UNITED STATES PATENT AND TRADEMARK OFFICE

APPLICATION NO.	FILING DATE	FIRST NAMED INVENTOR	ATTORNEY DOCKET NO.	CONFIRMATION NO.
10/806,070	03/22/2004	Johannes Theodorus Maria Slingerland	VER-180XX	1513
207	7590	07/21/2006	EXAMINER	
WEINGARTEN, SCHURGIN, GAGNEBIN & LEOVICI LLP TEN POST OFFICE SQUARE BOSTON, MA 02109			NGUYEN, TRINH T	
			ART UNIT	PAPER NUMBER
			3644

DETAILED ACTION

【図7】

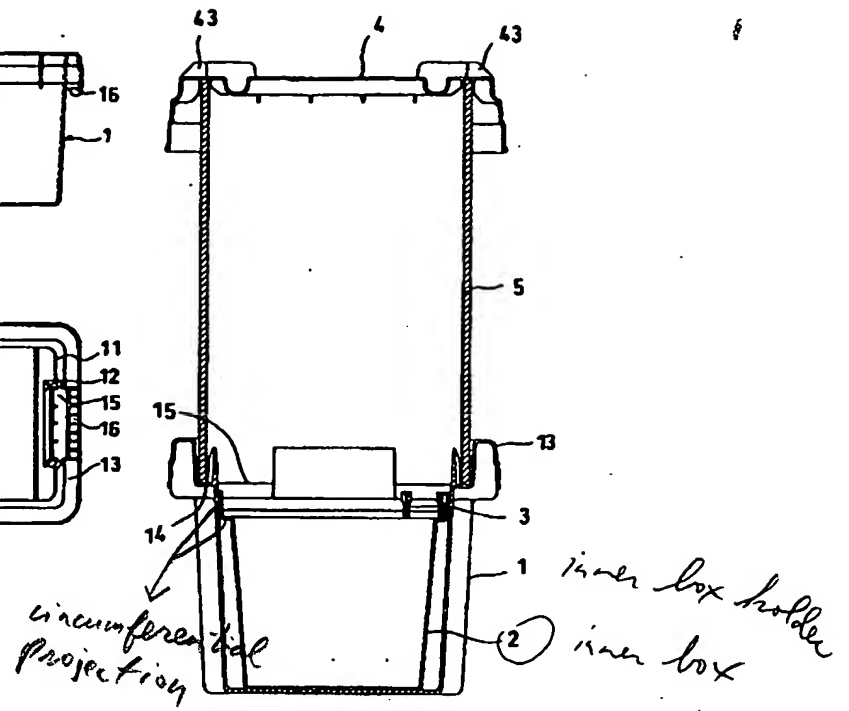
7. Claims 28 and 29 are rejected under 35 U.S.C. 103(a) as being unpatentable over JP2002-326630 (JP'630) in view of JP2003-170981 (JP'981; see Figure 7 attached at the end of this Office Action for further explanation).

JP'981 teaches a box assembly similar at that of JP'630 wherein JP'981's box assembly having a circumferential projection so as to engage the two boxes (1,2)

together (see Figure 7 especially). It would have been obvious to one having ordinary skill in the art at the time the invention was made to have modified the box assembly of JP'630 so as to include the use of a circumferential projection, in a similar manner as taught in JP'981, since to do so would allow the two boxes to be engaged more securely and thus provide a more stable stacking manner.

11. In response to Applicant's arguments that JP'981 is completely silent as to a circumferential projection, Applicant is referred to Figure 7 of JP'981 attached at the end of this Office Action for further explanation.
